DATE: April 3, 2020  
TO: Gabe Sevigny, PCD-Planning  
FROM: Jeff Rice (719-520-7877), PCD-Engineering  
SUBJECT: MS-20-002 – Dwire Storage Yard Filing No. 1  
First Submittal

**LSC Responses (7-11-2020): See below.**

# LSC Responses to TIS Redline Comments

RE: Dwire Storage Yard  
El Paso County, CO  
Transportation Memorandum  
LSC #194930

Figure 3  
 Site-Generated Traffic  
 Dwire Storage Yard (LSC #194930)

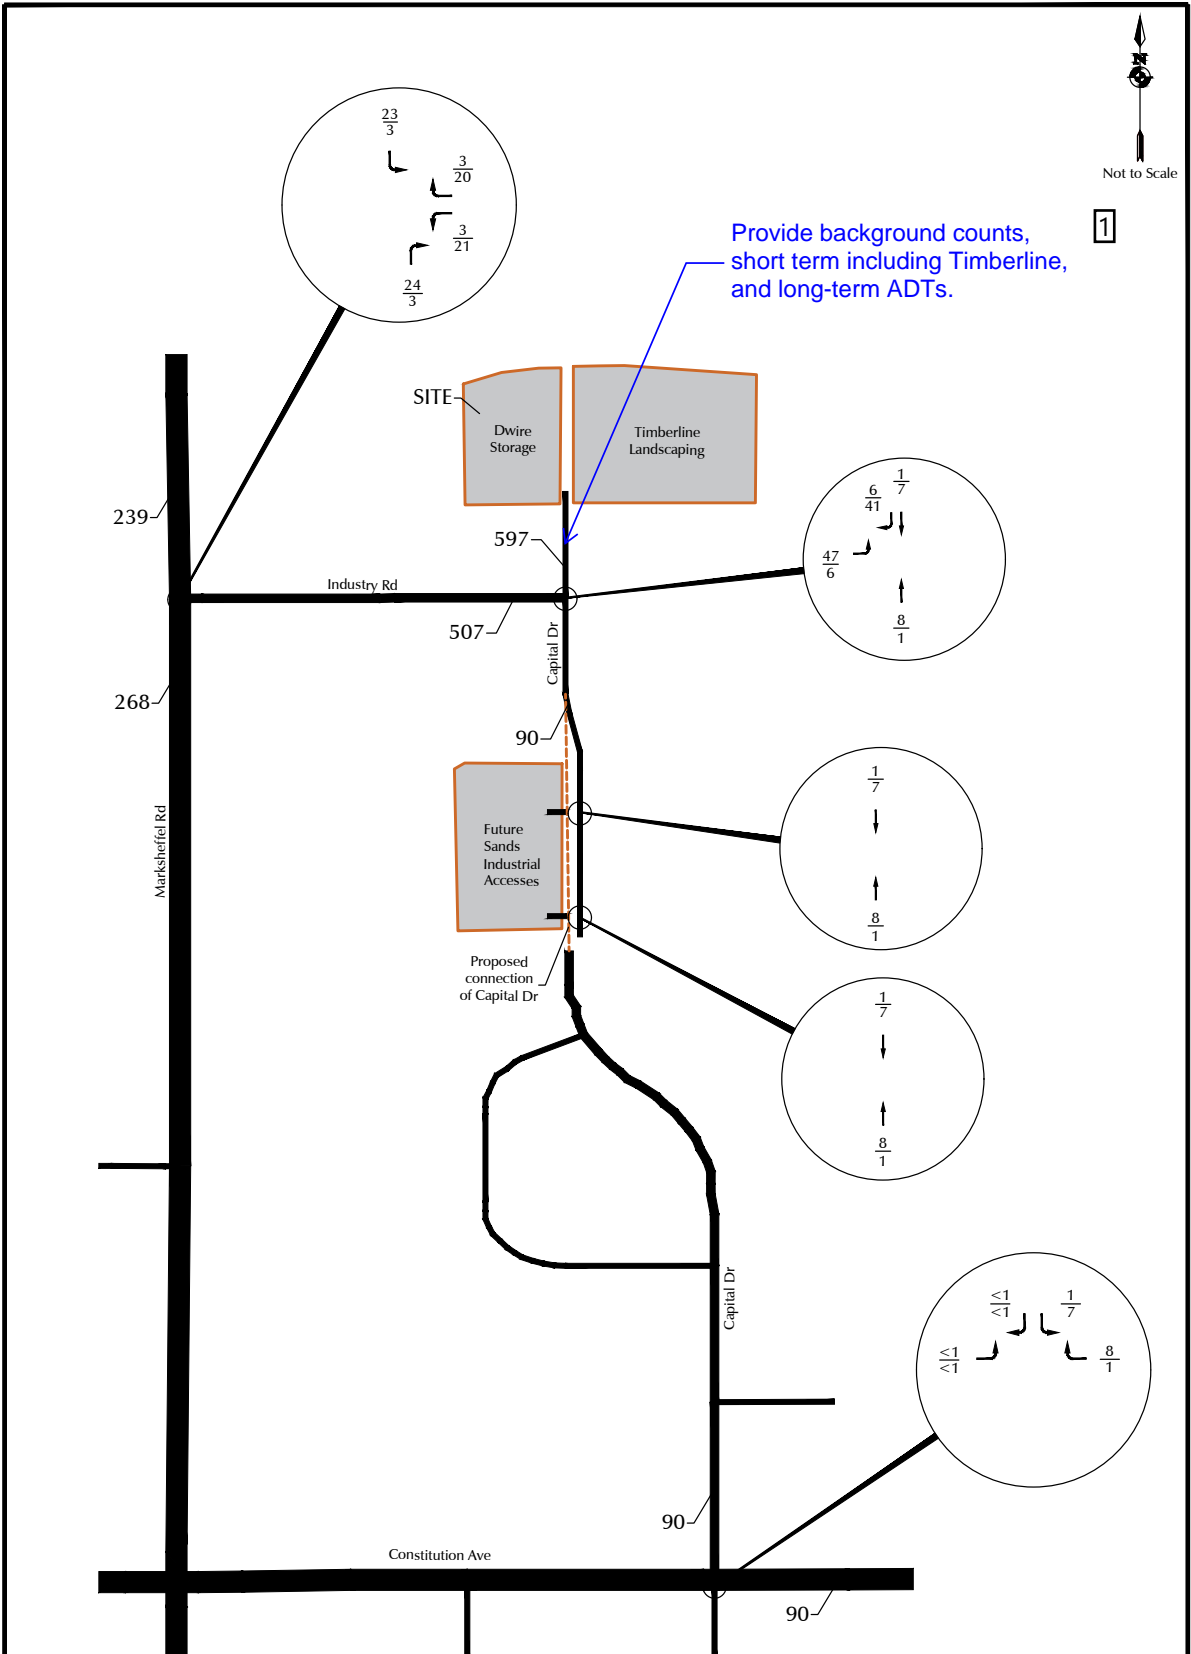
Provide background counts, short term including Timberline, and long-term ADTs.

[Provide background counts, short term including Timberline, and long-term ADTs.](#)

LSC Response: Figure 5 of the updated report presents background traffic for the Sands Industrial as well as a background component for future additional development within this overall business park area.

The updated report explains that Timberline Landscaping (including existing buildings/business operations) trip generation is included in the existing traffic volumes. Existing traffic volumes for the NORTH LEG of the intersection of Industry Drive/Capital Drive include Timberline Landscaping traffic along with traffic from other existing businesses with access to Capital Drive north of Industry Drive.
